Re: Thorndike Place - Hearing Feb. 1 Response

Thank you for confirming receipt of the Coalition's letter dated Feb. 7th in response to the last hearing of Feb. 1st.

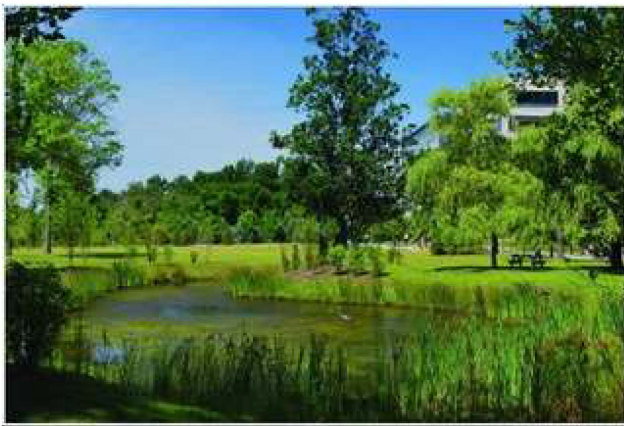
To our knowledge wells were installed last summer on the site for Thorndike Place - please see recent photo below.

As referenced in our letter, comment #3 asks the Con Comm to **confirm the monitoring of the installed wells**, in the spring months, that the **data gathered be submitted and made publicly available**.

Is the Con Comm not aware of the existence of these wells?

As a point of clarification, your Comment #3 makes reference to monitoring wells. There are no monitoring wells associated with or installed onsite for Thorndike Place - they were test pits measured at a single point in time, and are not continuously monitored.

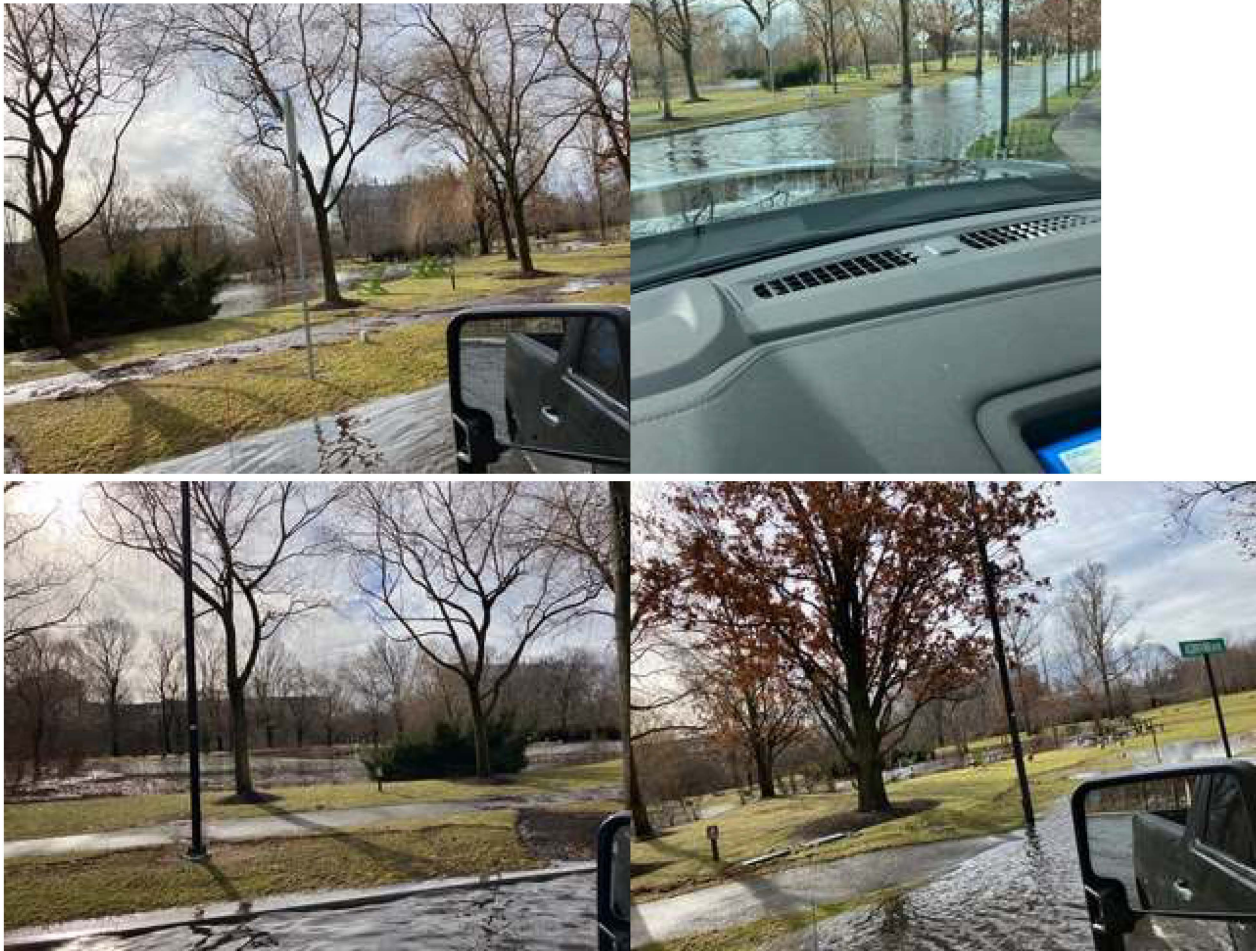
As a point of reference, one of BSC Group's completed projects listed on their website is Cambridge Discovery Park, located on Route 2 directly across from the Mugar site. The photo below of the project and excerpt is taken directly from their website:

As compared to photos taken of the same site during the recent storm on Jan. 10, 2024 - Is this what our future holds?
